Form 3160-5
(June 2019)UNITED STATES
DEPARTMENT OF THE INTERIOR
BUREAU OF LAND MANAGEMENTFORM APPROVED
OMB No. 1004-0137
Expires: October 31, 2021**SUNDRY NOTICES AND REPORTS ON WELLS**
Do not use this form for proposals to drill or to re-enter an abandoned well. Use Form 3160-3 (APD) for such proposals.

8. Well Name and No. HAWK 35 FED/506H

EOG respectfully requests an amendment to our approved APD for this well to reflect the following changes:

Revised Permit Information 10/17/2022:

WELL LOCATION AND ACREAGE DEDICATION PLAT

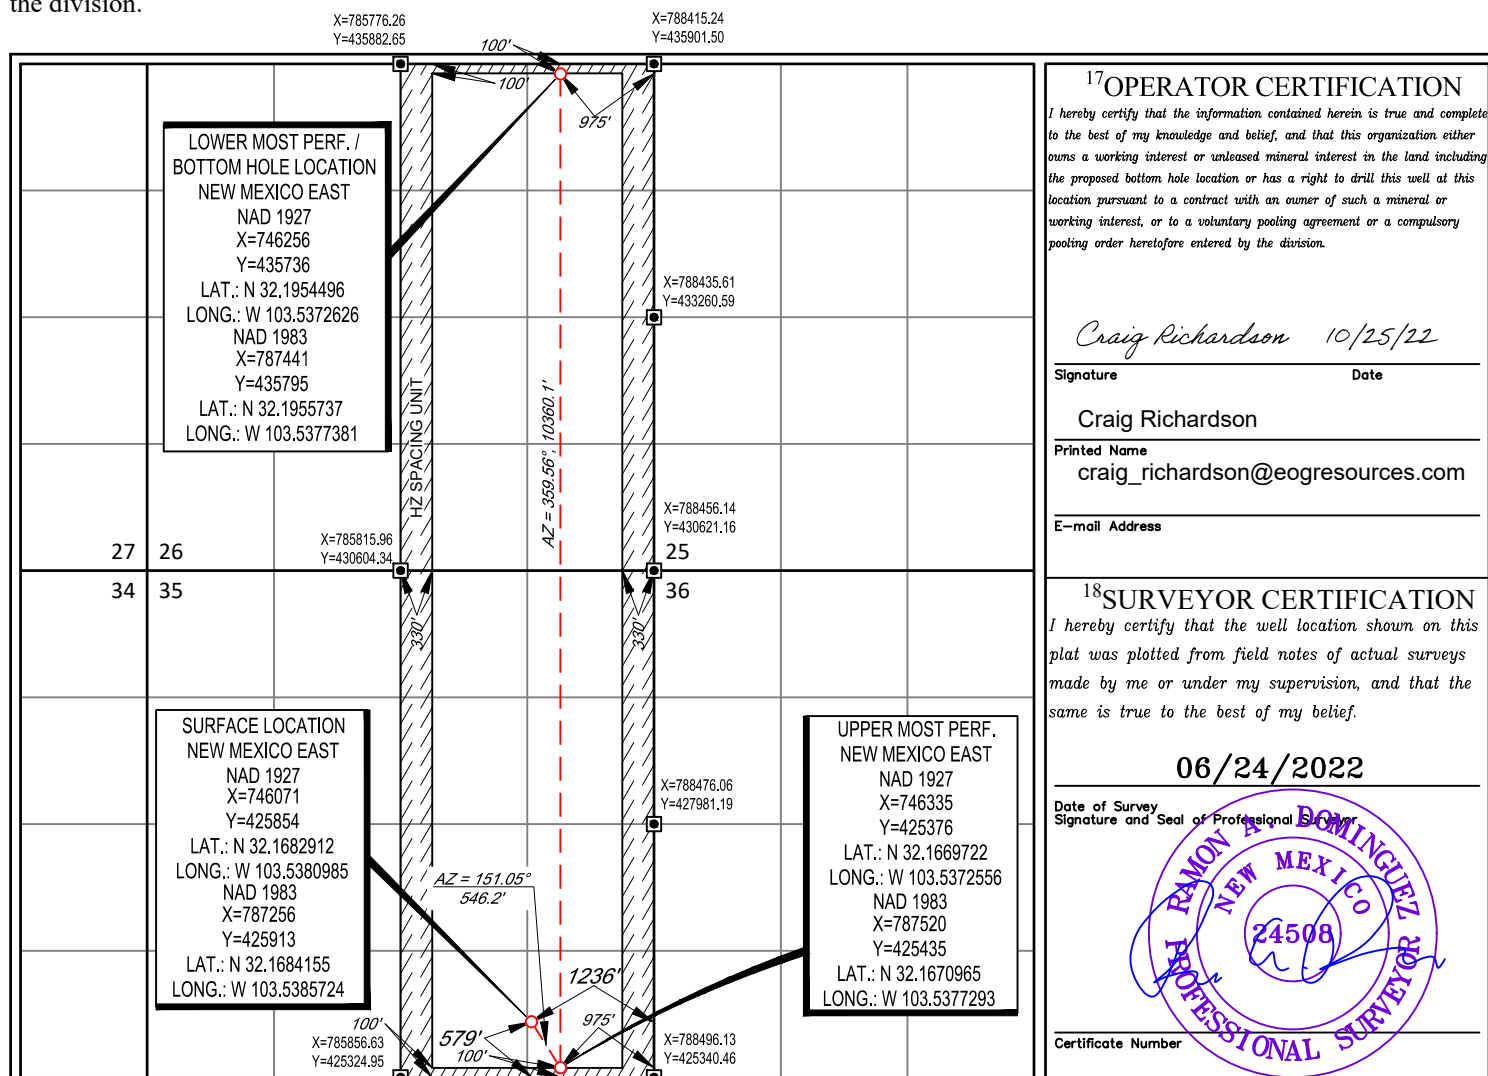
Change BHL from T-24-S, R-33-E, Sec 26, 100' FNL, 1650' FEL, Lea Co., NM, to T-24-S, R-33-E, Sec 26, 100' FNL, 975' FEL, Lea Co., N.M.

UL or lot no.	Section	Township	Range	Lot Idn	Feet from the	North/South line	Feet from the	East/West line	County
A	26	24-S	33-E	-	100'	NORTH	975'	EAST	LEA
